### **ADDITIONAL INFORMATION**

**SDCC Reg Ref: SD22A/0403**

**Development:** Two, 2 storey dwellings and associated site works on the site of and adjacent to an existing 2 storey dwelling (for clarity the existing dwelling Lynbrook is to remain); proposed dwelling A - 4 bedrooms, 241 sq.m; proposed dwelling B - 5 bedrooms, 240 sq.m; access is proposed to be by an existing driveway from the Whitchurch Road serving the existing dwelling on site; the existing driveway will be extended to serve the proposed dwellings; 4 car parking spaces; on-site drainage treatment and additional soft and hard landscaping are proposed as part of the development.

**Location:** Lynbrook, Whitechurch Road, Rathfarnham, D16T2P7

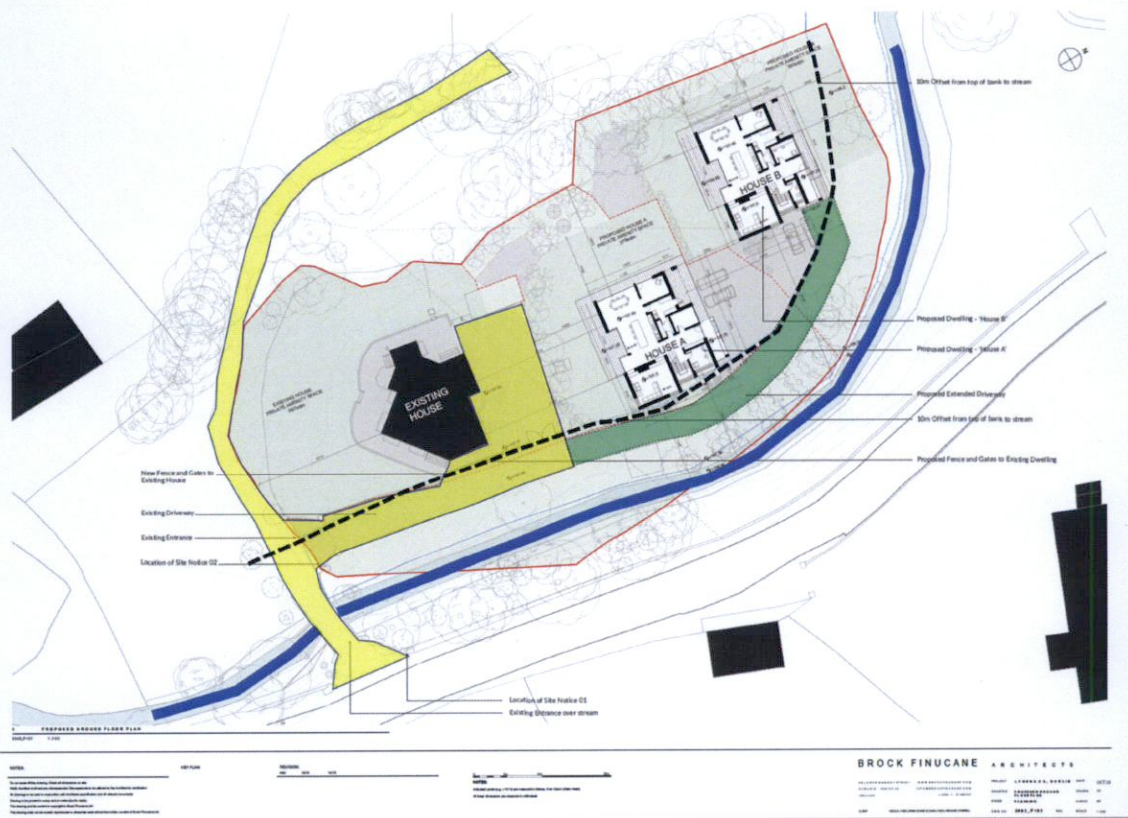
The proposed development is too close to adjacent stream at 5m. Water Services require a minimum setback distance of 10m from proposed development to the top of bank of adjacent Stream east of site.

(i) The applicant is requested to submit the following: Submit a drawing in plan and cross-sectional view showing the setback distance from edge of driveway development to the top of bank of adjacent stream. The distance should be taken at the narrowest point between edge of entrance driveway to the top of bank of adjacent stream east of site.

The entirety of the two proposed dwellings are located in excess of 10 metres from the top of the stream bank as indicated in originally submitted drawing P101- extract below for ease of reference. This offset was integrated at concept design stage to respect the setting of the site.

In addition, no walls, gates, other buildings or fixtures are proposed to be located within this 10 metre zone. It is solely proposed that the pre-existing driveway to the existing house on the site, which is already located within 10 metres of the stream bank, be extended to serve the proposed dwellings.

- Blue Line: Stream
- Black Dotted Line: 10m from top bank of stream
- Yellow Hatching: Existing Access Road & Driveway
- Green Hatching: Proposed Extended Driveway
